Errata Sheet

SLG46620

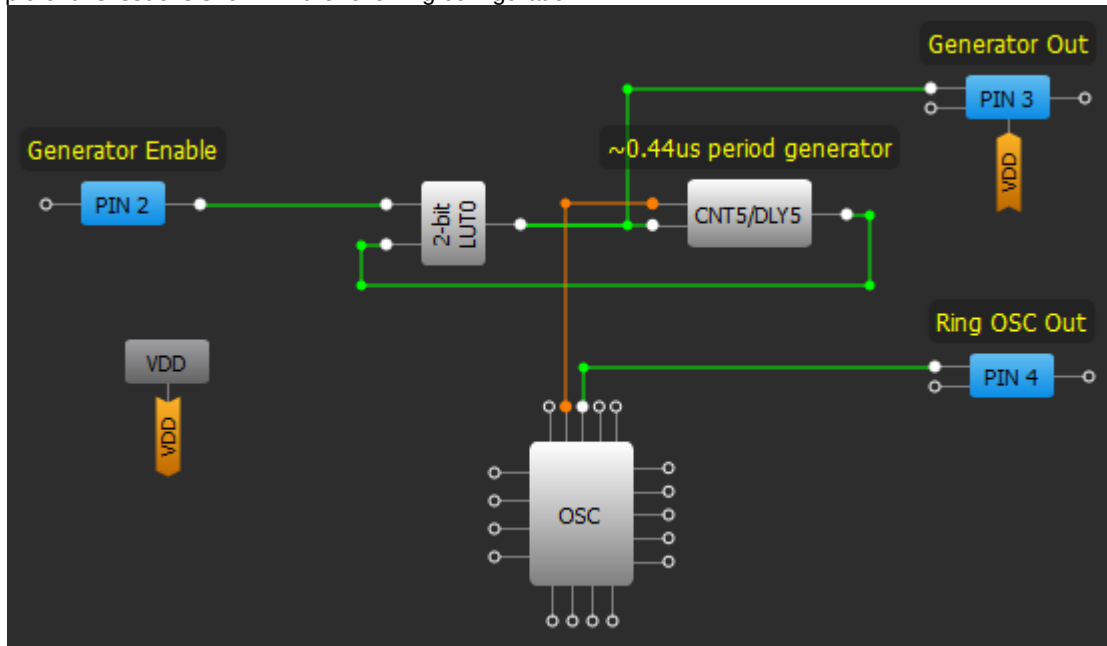
The output of the ACMP incorrectly goes low even when IN+ is greater than IN- if the RING OSC is active when the WS signal rises

Channel 1 – ACMP out

Channel 2 – WS OUT

- Avoid using the RING OSC with the WS Controller, or add a filtering block on the ACMP output to filter out the glitch.

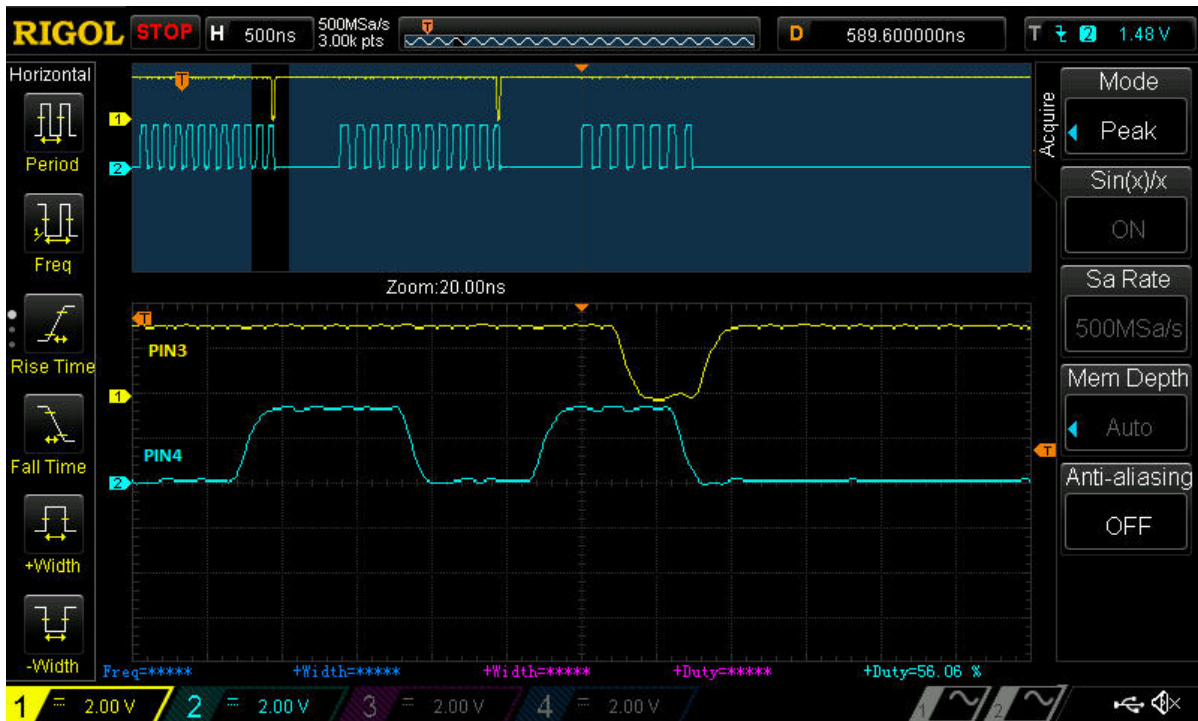
The Ring OSC has a longer settling time when configured as Auto Power On in the designs that have very short Ring OSC disable time. An example of this issue is shown in the following configuration:

The configuration shown above generates a periodical signal with a frequency defined by the Delay cell and started by a high signal on PIN2. The issue becomes apparent in a longer settling time when the scheme generates short pulses (Delay is configured as a rising edge delay only). See waveform below.

- Set Ring OSC power mode to “Force Power On”
- or, Set Turn on by register option in BG (Band Gap) block as “Enable”

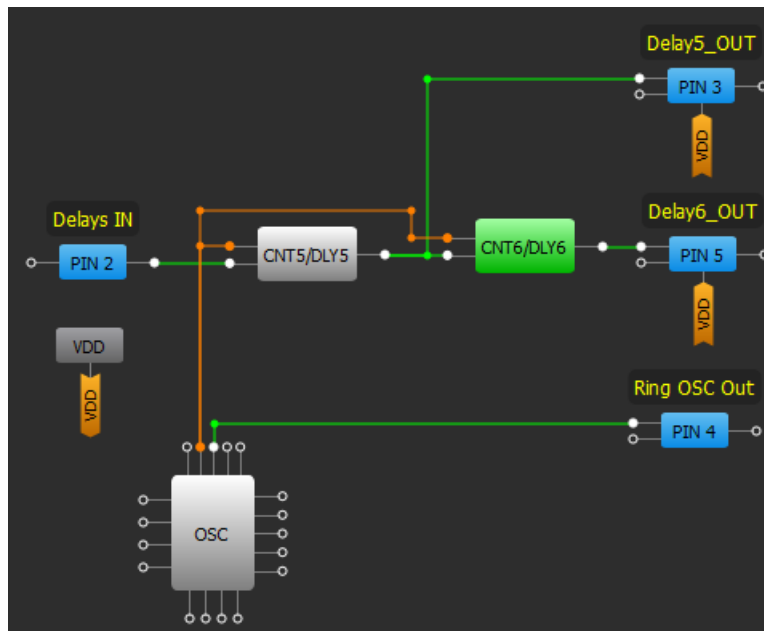
Channel 1 – 2-bit LUT0 output; Channel 2 – Ring OSC output

Such behavior will lead to substantial error in period calculations if the delay time is relatively small.

A similar situation can occur while using two connected delays (all edge detect types except for a pair “Rising edge DLY – Falling edge DLY”).

In the following example, Delay5 and Delay6 are configured in the same way. However, Delay5 time is 11.4us instead of expected 0.4us (Delay5 time).

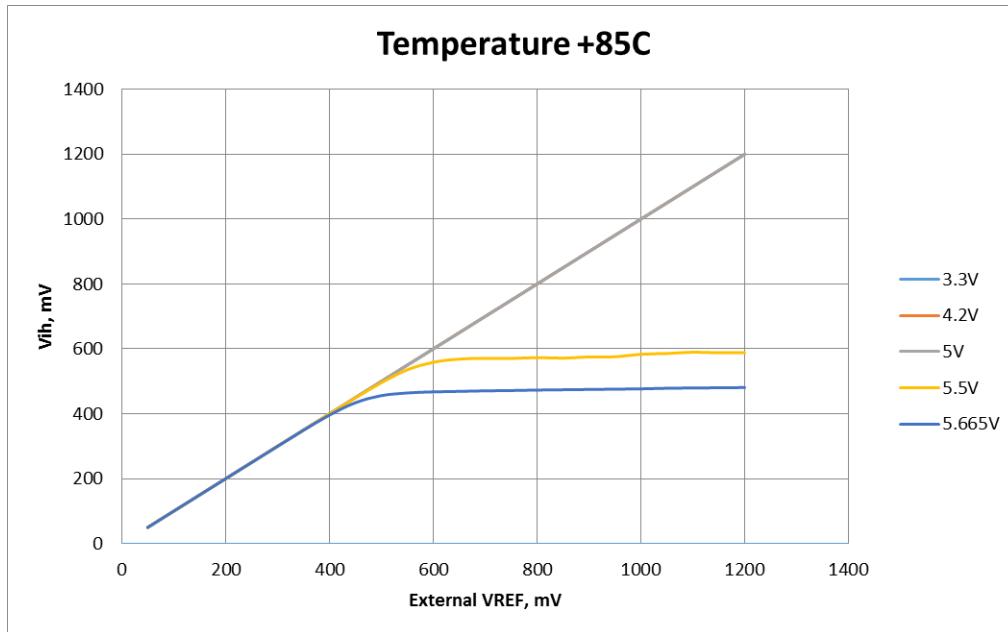
When using external Vref source, the ACMP comparison may happen at wrong threshold if the external Vref voltage is higher than a particular value (please see figure below) at high VDD values (> 5V) and high temperature.

- Avoid using ACMPs in such conditions.

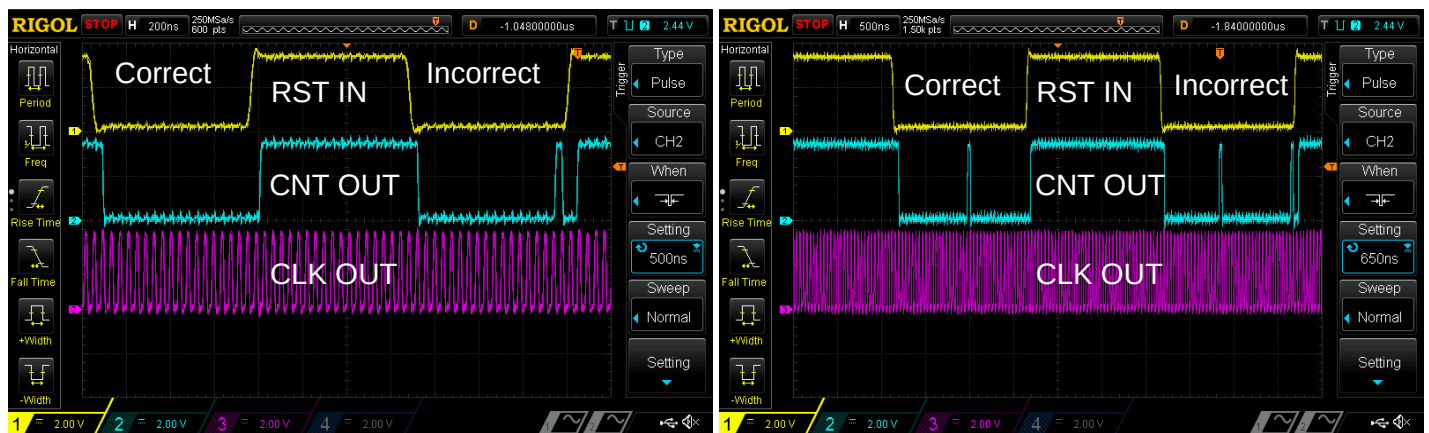
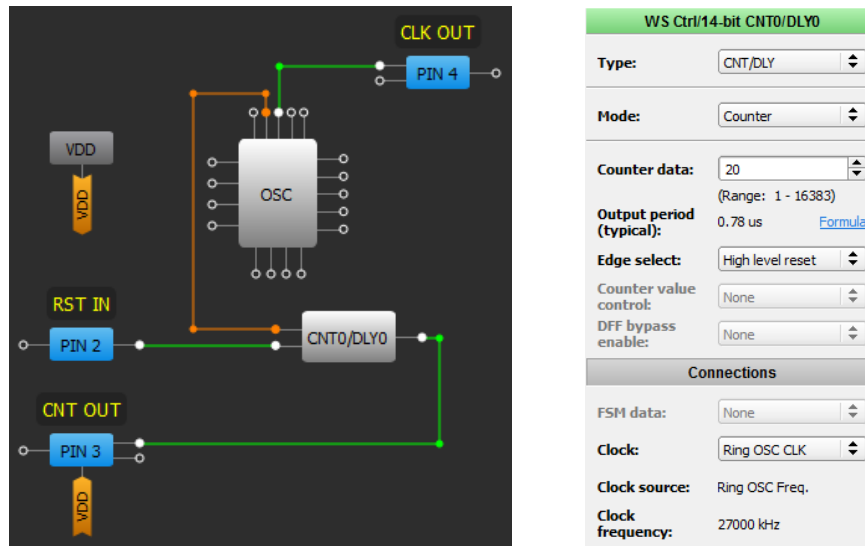
If the Counter Reset occurs at a time very close to a rising edge of the clock signal during clock signal generation (for example OSC operation), there is a possibility that the Counter Data of the Counter is reset incorrectly and the counter end signal (HIGH pulse) may appear faster than expected. This phenomena appears more frequently the higher the clock frequency is.

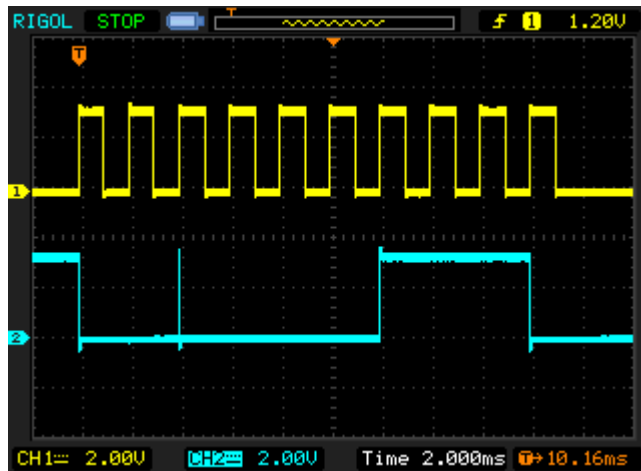
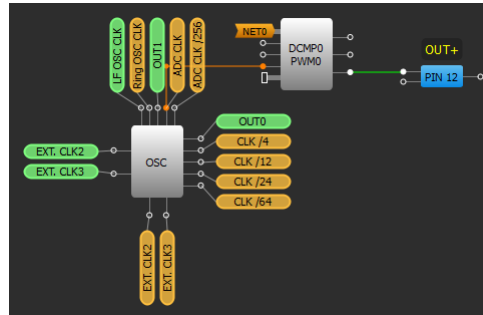
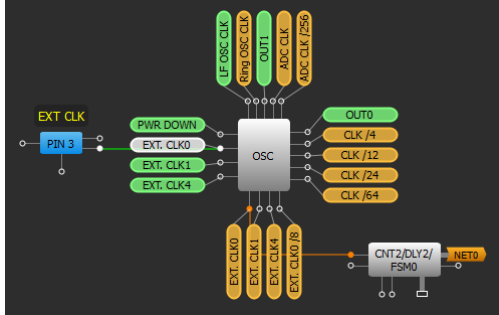
DCMP's OUT+ output may have a glitch when the input data is changed. This issue appears more frequently the higher DCMP clock is.

For example, DCMP IN+ sources from FSM0 and IN- from Register0. DCMP is clocked from the Ring OSC.

1.9 kHz OSC long start-up:

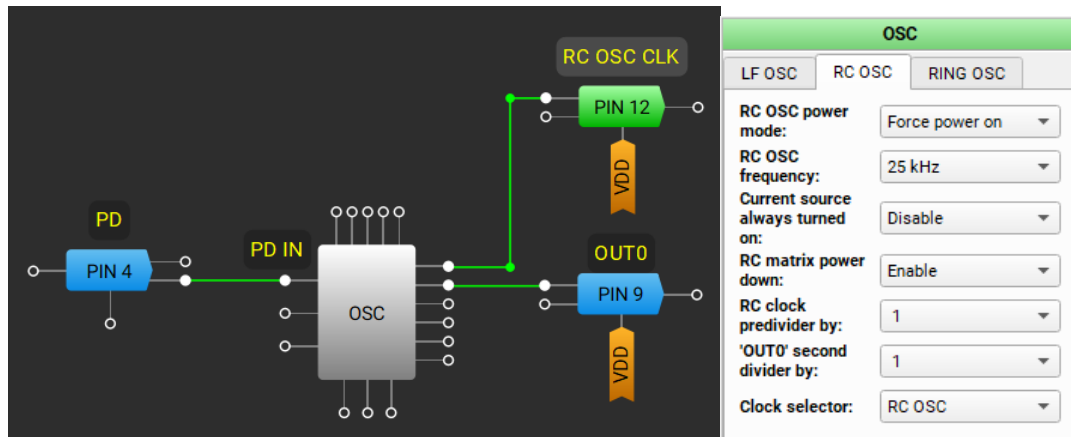
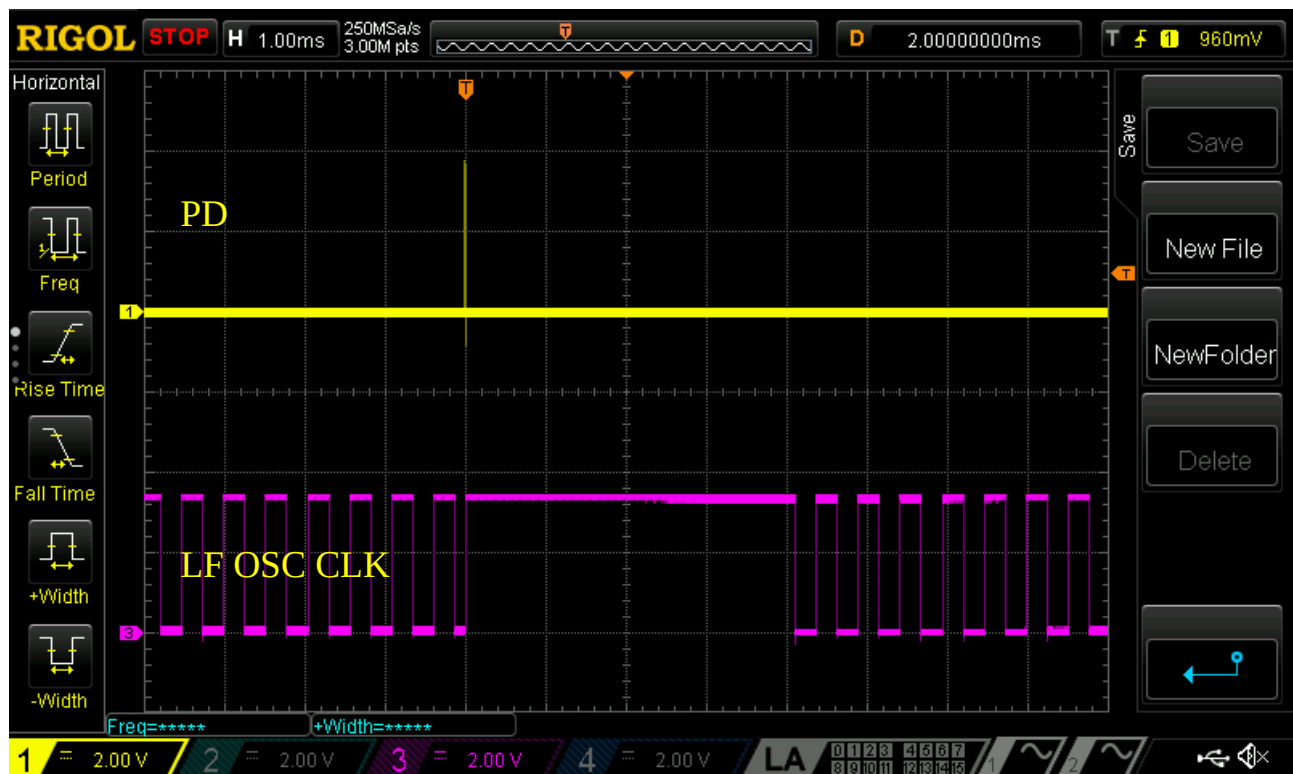
If a pulse with a duration of less than ~40 ns is applied to the PWR DOWN input of an oscillator, the oscillator outputs remain stuck for milliseconds.

The issue is observed for all available oscillators.

Avoid applying glitches to the PWR DOWN input of an OSC.
